Contract Description: Maple Floor Replacement - Sportsplex

..Title
Sportsplex Gymnasium Flooring Change Order

..Title
Sportsplex Gymnasium - Change Order

WEST 1 OF 2

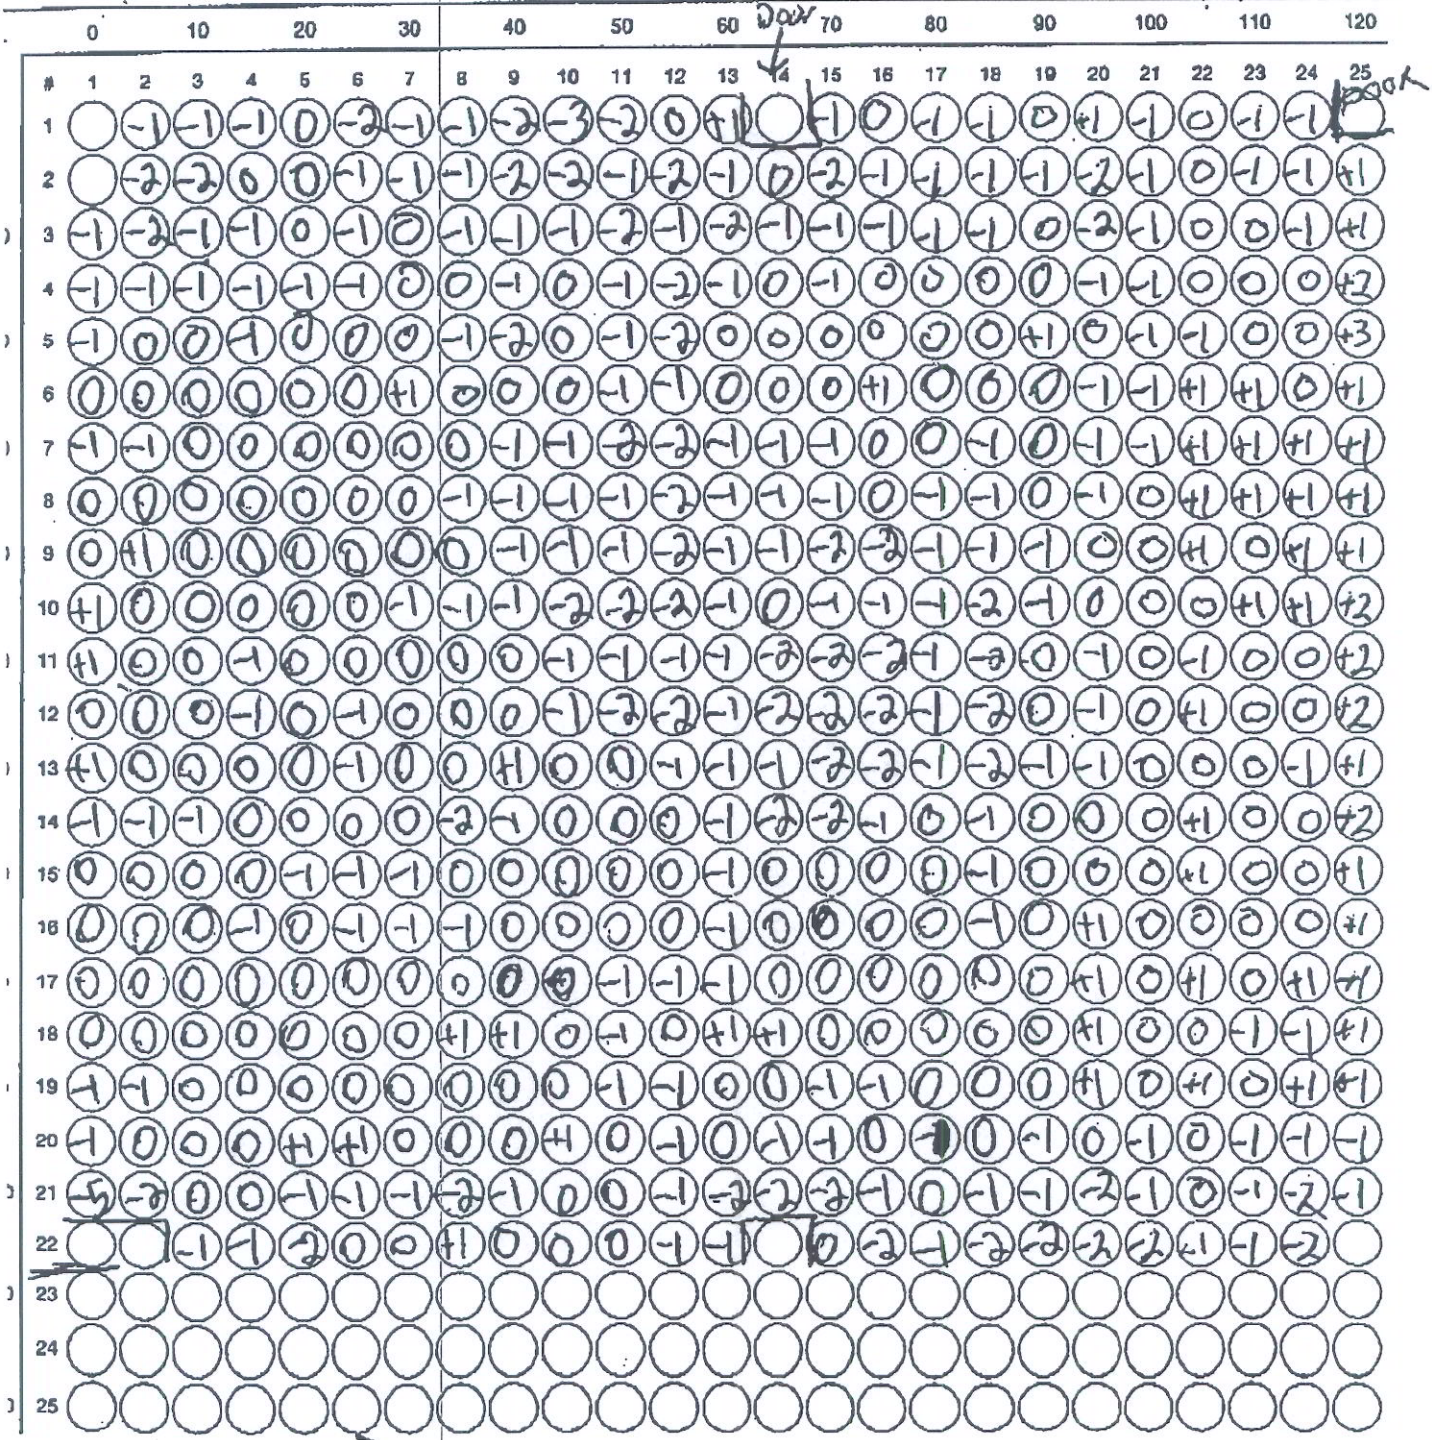
Here is a copy of the concrete floor survey. As we discussed, the concrete should have been leveled before the Connor floor was installed but it was not. Some areas are not within tolerence for a maple gym floor. I can estimate a cost to properly level the concrete.

History
Upon removal of the existing gym flooring it was discovered that the concrete floor is not level in the northeast corner of the building. We have received an estimate from

Recommended Action/Motion
I move to approve a change order to Floors Incorporated $4,700.00 for the leveling of the gymnasium concrete sub-floor.
